APPLICATION NO.	FILING DATE	FIRST NAMED INVENTOR	ATTORNEY DOCKET NO.	CONFIRMATION NO.
10/684,684	10/15/2003	Kohei Yamanaka	Q76899	3402
23373	7590	03/08/2007	EXAMINER	
SUGHRUE MION, PLLC 2100 PENNSYLVANIA AVENUE, N.W. SUITE 800 WASHINGTON, DC 20037			GARCIA, ERNESTO	
			ART UNIT	PAPER NUMBER
			3679	
SHORTENED STATUTORY PERIOD OF RESPONSE		MAIL DATE	DELIVERY MODE	
3 MONTHS		03/08/2007	PAPER

Office Action Summary	Application No.	Applicant(s)	
	10/684,684	YAMANAKA ET AL.	
	Examiner	Art Unit	
	Ernesto Garcia	3679

DETAILED ACTION

Fig. 4.

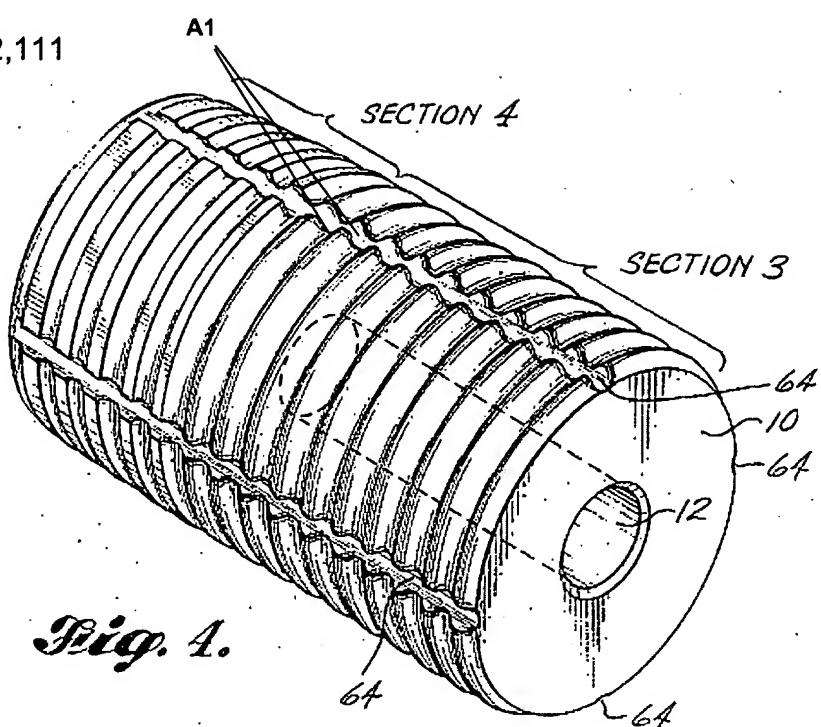
Regarding claim 1, Dent discloses, in Figures 4 and 8, a structure comprising a shaft member **10** and a cylindrical member **22**. The shaft member **10** is formed out of a

first material (col. 1, lines 18-24). The shaft member **10** has an outer periphery formed with an axial groove **64** and a circumferential groove **36** (see Figure 3). The axial groove **64** and the circumferential groove **36** have a cross-section having opposed faces **A1** (see marked-up attachment) substantially parallel to each other. The cylindrical member **22** is fitted to the outer periphery of the shaft member **10**. The cylindrical member **22** is formed out of a second material greater in linear expansion coefficient than the first material (col. 1, lines 18-24). A caulked portion (not shown; see col. 6, lines 29-34) is provided to the cylindrical member **22** at an intersection of the axial groove **64** and the circumferential groove **36**. The caulked portion has a continuous and deformed inner surface in press contact with the opposed faces **A1** of the axial groove **64** and the circumferential groove **36**. The axial groove **64** is greater in depth than the circumferential groove **36** (col. 4, lines 35-38).

Regarding claim 4, a circumferential width of the caulked portion is greater than a circumferential width between the opposed faces **A1** of the axial groove **64** at the intersection.

Regarding claim 5, a first caulked part corresponding to the circumferential groove **36** and a second caulked part corresponding to the axial groove **64**. The second caulked part is arranged substantially in a middle of the first caulked part.

Regarding claim 9, the cylindrical member **22** is apart from the shaft member **10** by a clearance **A2** except at the caulked portion **18**.

The axial groove **64** has a cross-section having opposed faces **A1** (see marked-up attachment) substantially parallel to each other. The cylindrical member **22** is provided to the outer periphery of the shaft member **10**. The cylindrical member **22** is formed out of a second material greater in linear expansion coefficient than the first material (col. 1, lines 18-24). A caulked portion (not shown; see col. 6, lines 29-34) is provided to the cylindrical member **22** at a position corresponding to the axial groove **64** of the shaft member **10**. The caulked portion has a deformed inner surface in press contact with the opposed faces **A1** of the circumferential groove **36**. The cylindrical member **22** is spaced apart from the shaft member **10** by a clearance **A2** except at the caulked portion.

Regarding claim 23, the clearance **A1** is sufficient to loosely fit an inner periphery side of the cylinder member **22** over the outer surface of the shaft member **10**.

Regarding claim 24, the clearance **A1** is established at room temperature.

Fig. 8.

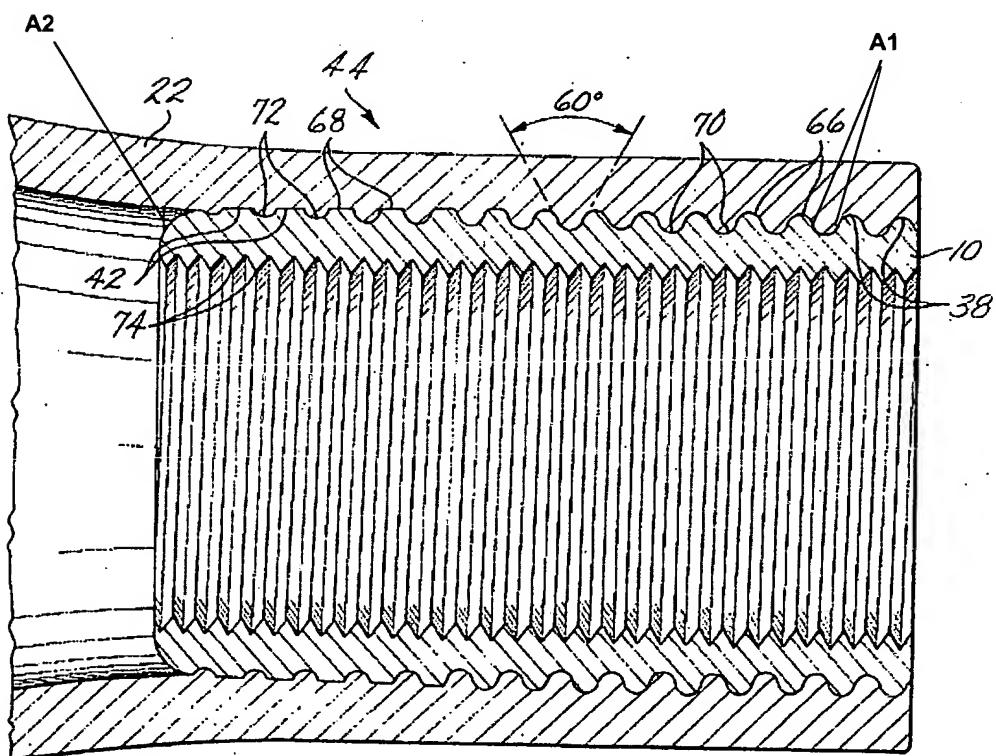
Regarding claim 21, Dent discloses, in Figures 4 and 8, a structure comprising a shaft member **10** and a cylindrical member **22**. The shaft member **10** is formed out of a first material (col. 1, lines 18-24). The shaft member **10** has an outer periphery formed with at least one of an axial groove **64** and a circumferential groove **36** (see Figure 3).
